JW MARRIOTT BONNET CREEK
CHELONIA PARKWAY

Project Number
R305894.01

CMU DETAILS

S6.31 - 1 TYPICAL CMU WALL MINIMUM REINFORCEMENT

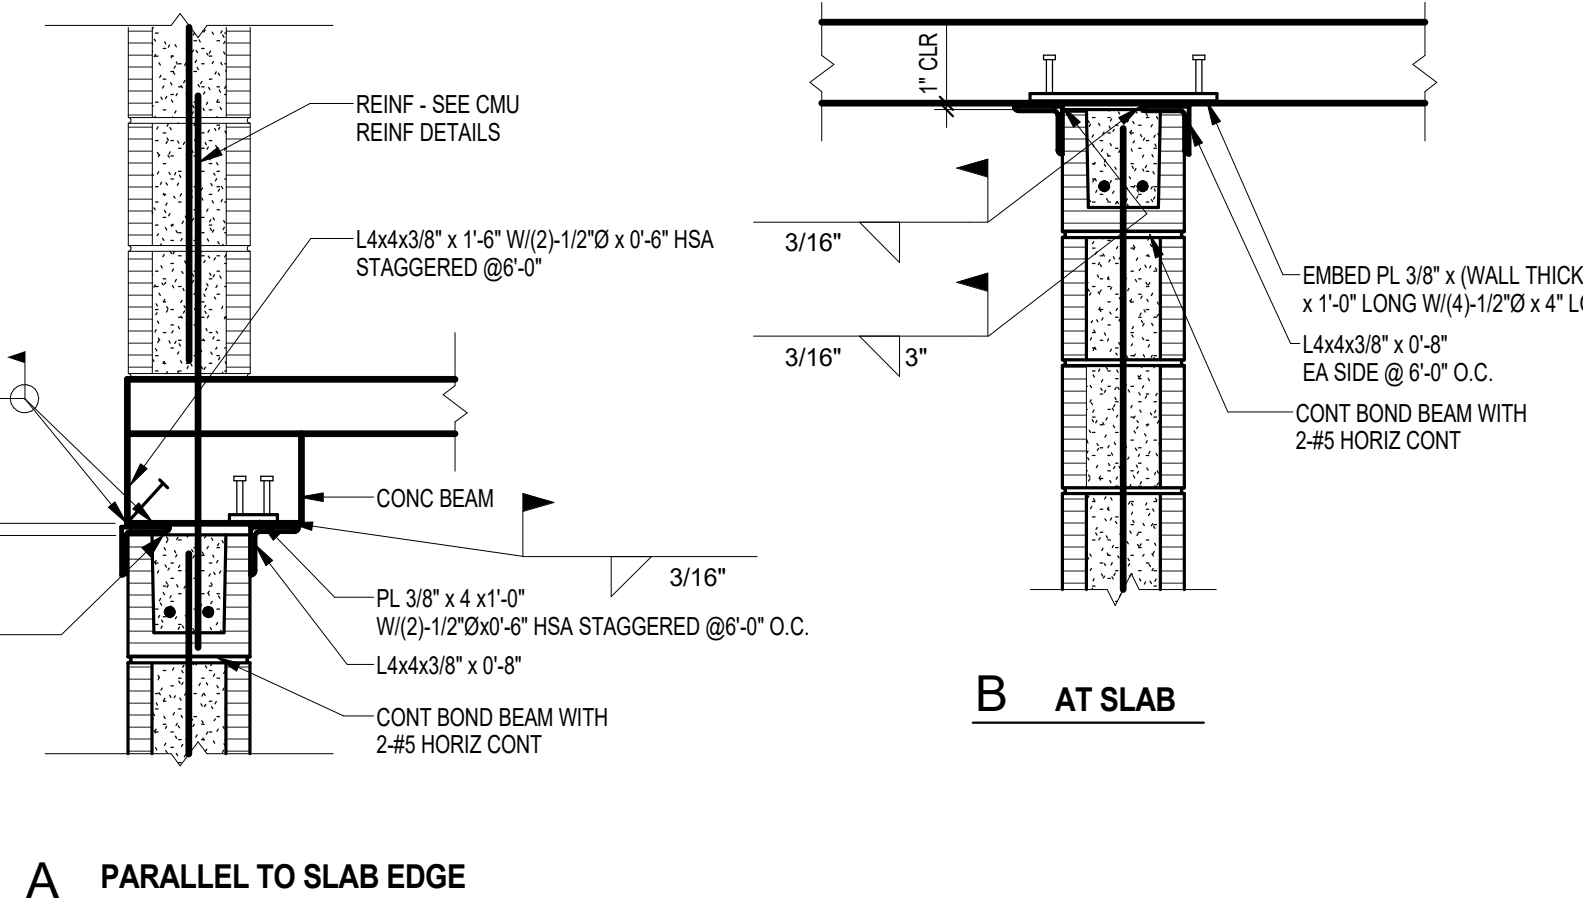
RFI #0345 - WALLS THAT ARE
16'-4" OR LOWER ARE TO BE
8" THICK UNLESS SHOWN
OTHERWISE BY
ARCHITECTURAL DRAWINGS
